PRODUCT CHANGE NOTIFICATION

Product Identification: Bel SI-x6xxx-F series of Vertical Mount ICMs

PCN Number: PC2180072

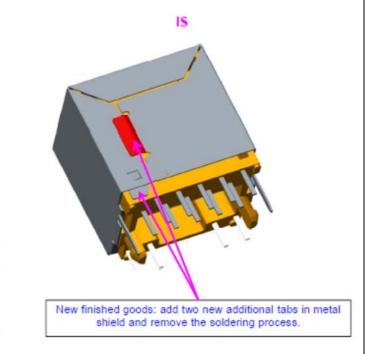
Description of the Change (s): Bel is updating the outer shield latching scheme on all the SI-x6xxx-F series of ICMs by adding 2 additional tabs at the latch area and removing the soldering operation of the latch area. The 2 added tabs will keep the left shield panel from pushing inward, while also keeping the right shield panel securely against the main plastic connector body preventing the latch from becoming disengaged or unhinged. The former soldering operation will be removed and will have a positive visual appearance of the entire connector. Please refer to the images below for more details.
